**UNITED STATES OF AMERICA
BEFORE THE
DEPARTMENT OF ENERGY**

Energy Conservation Program: Energy)	EERE-2014-BT-STD-0031
Conservation Standards for Consumer)	RIN 1904-AD20
Furnaces)	87 Fed. Reg. 40590

**COMMENTS OF
THE AMERICAN GAS ASSOCIATION**

Dated: October 6, 2022

Figure 1: Market share of condensing furnaces vs. LCC savings

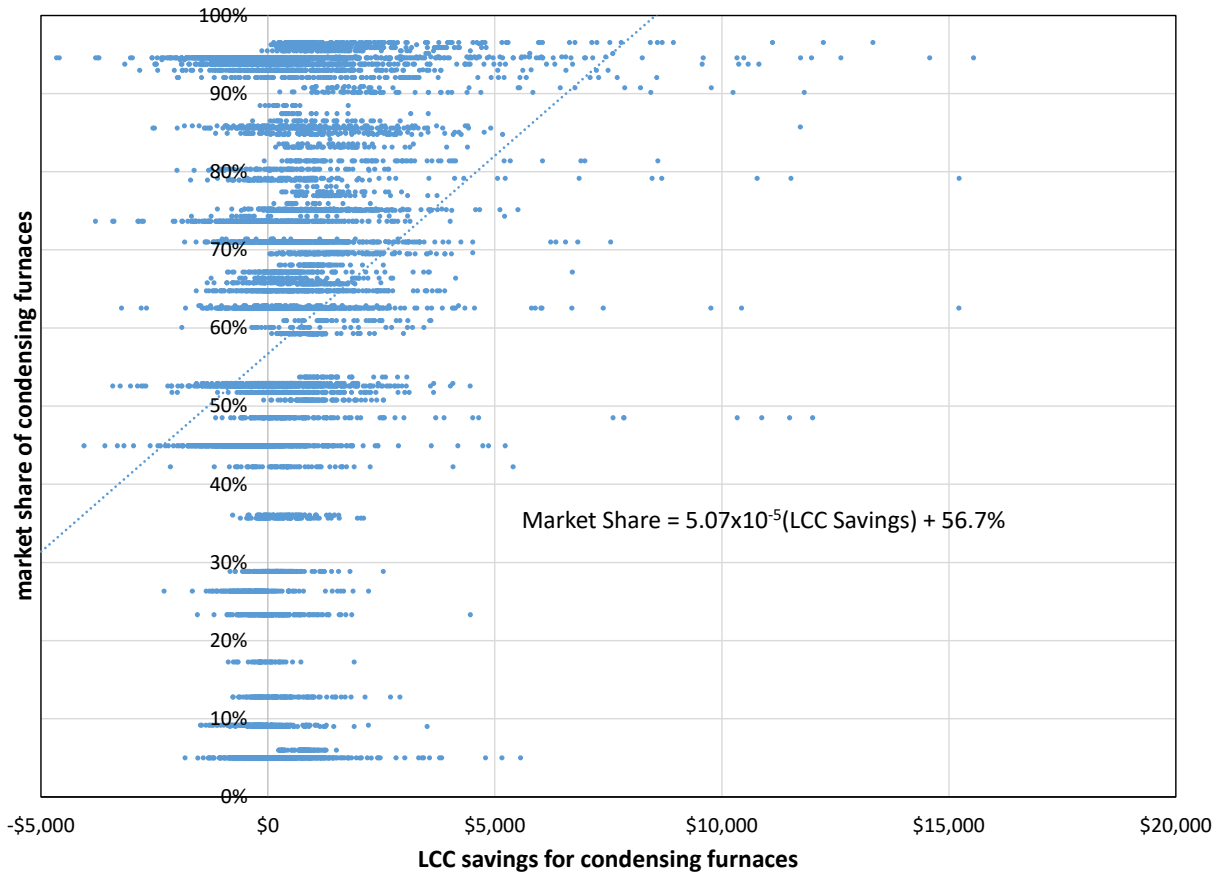
Figure 1 shows the market share of condensing furnaces, 90% AFUE and higher, vs. the blended LCC savings for condensing furnaces. The blended LCC savings is the weighted average of LCC savings for each condensing furnace efficiency weighted by the relative market share of those efficiencies. Market shares are specific to each state and installation type (replacement or new).

While there is a scatter in the data, this should be expected (the 10,000 trials contain different buildings, new and replacement furnaces, different incomes, *etc.*). The least squares best-fit line indicates a relationship between market share and LCC savings and that increasing LCC savings correlates with increasing market share. Further, the Pearson correlation coefficient between these variables is 0.243, with a p-value of 0.000. It is, therefore, more than 99.9% certain that these variables are positively correlated. Note also that the use of blended LCC savings is not necessary for a positive correlation; the Pearson correlation coefficient for condensing furnace market share for 90, 92, 95, and 98% AFUE LCC savings relative to 80% AFUE is 0.215, 0.228, 0.239, and 0.233 respectively, all have a p-value of 0.000. While this analysis is sufficient to prove beyond a reasonable doubt that the opportunity consumers have to save money relative to an 80%

Another interesting feature of Figure 1 is that the intercept of the y-axis is above 50%, meaning that the expected market share of condensing furnaces is above 50%, even if there is no economic incentive to install them. This suggests that if there is a market failure, according to DOE's LCC model, the market failure is that consumers choose more efficient products slightly more often than they should be based on economics alone.

Figure 2: Average LCC savings vs. market share of condensing furnaces for replacement applications

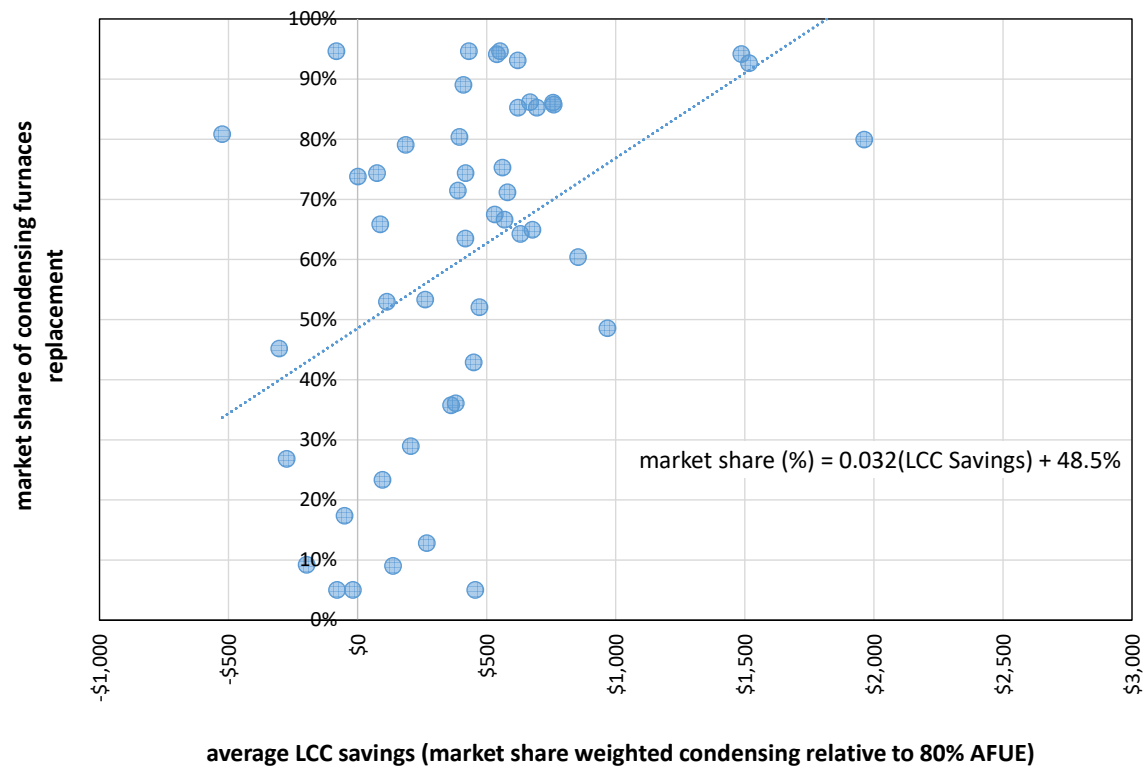
Figures 2 and 3 show the market share of condensing furnaces vs. average LCC savings with individual data points averaged by state. Again, there is a positive correlation between savings and market share in replacement and new construction applications. Unsurprisingly, in the case of new construction, LCC savings are higher, and there are no regions with a negative average LCC savings (because serious venting issues in new construction, designed for a condensing furnace, should never occur). Note that this portion of the analysis weights each region the same even though the number of data points between regions is not the same.

Figure 4: Percent of negative LCC outcomes for a 95% AFUE furnace relative to an 80% AFUE furnace vs. market share of condensing furnaces

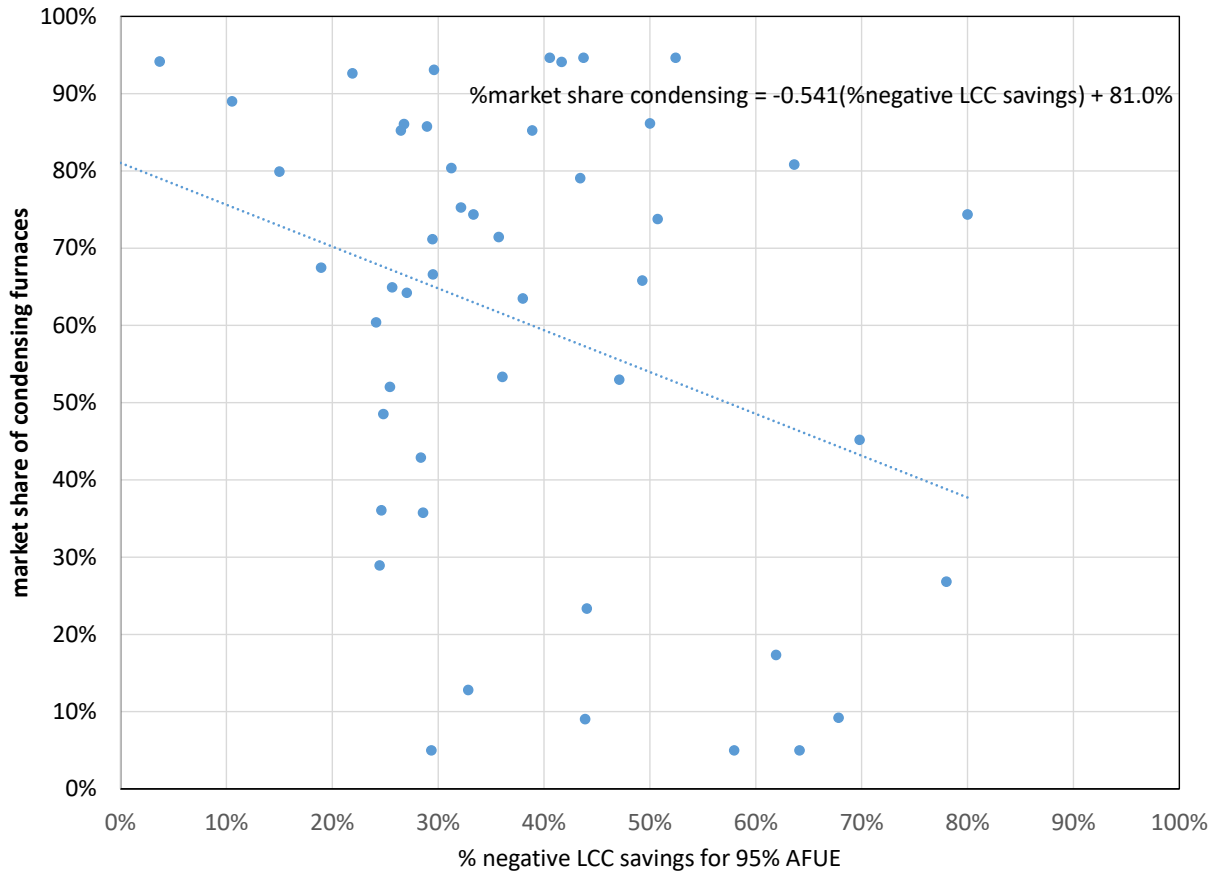
Percent of negative outcomes is another way to look at the data produced by this analysis. One would expect that if consumers were paying attention to economics, however imperfectly, there would be a negative correlation between the percent of negative LCC outcomes in a region and the market share in that region. If a large fraction of consumers experienced negative financial consequences from adopting condensing furnaces, one would expect that the market share of condensing furnaces in that region would be low. In this case, the analysis was limited to replacement situations as there are few negative outcomes in new construction situations. The Pearson correlation coefficient for the data displayed in Figure 4 is -0.321 with a p-value of 0.026, meaning that these data are negatively correlated with 97.4% certainty.

If consumers were perfectly assessing economic impact, all of the data points would fall on a line with 100% market share at 0% negative LCC outcomes and 0% market share where there are 100% negative LCC outcomes. Outcomes above the line indicate that the market share of efficient products is higher than it should be, and outcomes below the line indicate that the market share of efficient products is lower than it should be in a given region. Figure 5 shows this red line added to the prior Figure 4. There are 48 total data points on the graph, and 25 of them are above the line. These 25 points represent 53.6% of the underlying replacement trial cases. This shows again that if there is a systematic market error, the error is more likely that consumers are choosing overly efficient products than are economically justified than the opposite. However, on

Figure 5: Percent of negative LCC outcomes for a 95% AFUE furnace relative to an 80% AFUE furnace vs. market share of condensing furnaces with “perfect” market line added.

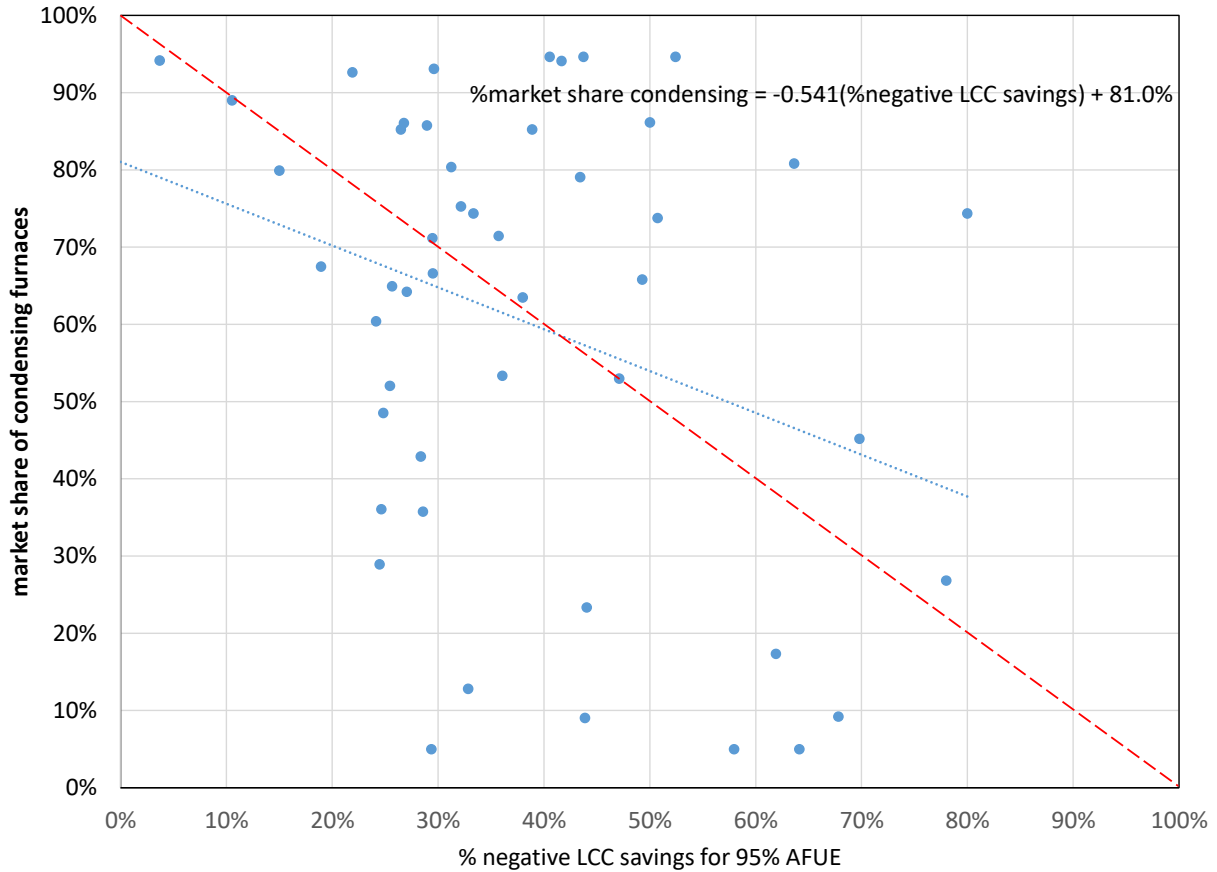
This analysis, using DOE’s LCC modeling spreadsheet, irrefutably and conclusively demonstrates that DOE’s method of randomly assigning furnace efficiencies in its base case is improper. Moreover, it demonstrates that any market failure results in greater adoption of high-efficiency equipment than would be expected by economics alone

Figure 10.2.1 Projection of No-New-Standards Case Efficiency Distribution for Non-Weatherized Gas Furnaces, 2029-2058

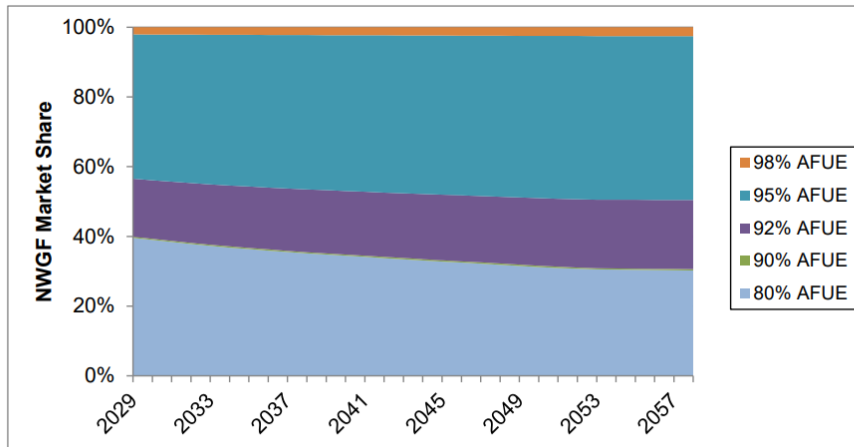
This is not only contrary to clear trends but also to DOE’s assessment of the market in other parts of its Proposed Rule. DOE claims in the NOPR that “[f]or each considered efficiency level in each product class, DOE calculated the LCC and PBP for a nationally representative set of housing units and, for NWGFs, commercial buildings.”¹²³ For example, DOE’s TSD provided a forecast for each AFUE level through 2058. That forecast projected that non-condensing furnaces would lose 10% of the market (from 40% to 30%) for AFUE 80 furnaces between 2029 and 2058. Found in DOE’s TSD, Section 10 Figure 10.2.1. But even that assumption is unreasonable. As noted above, AHRI’s data showed that non-condensing furnaces lost 10% of the AFUE 80 market between 2006 and 2015. DOE does not explain why that trend would not continue over the next 10 years (i.e., 2015-2025) or why it is reasonable to expect a slowdown in the trend that would reflect a loss in market share of only 10% over 43 years (2015-2058).

In short, it is arbitrary and capricious for DOE to assume no change to the market for AFUE 80 furnaces in its LCC analysis. Even the Department's TSD suggests at least a 10% decrease in non-condensing furnace sales, and that number is unreasonably low because it fails to account for market trends. As with other aspects of the LCC analysis, DOE must revisit its unsupported assumptions about market share and replace them with data, assumptions, or estimates that are actually supported by evidence.
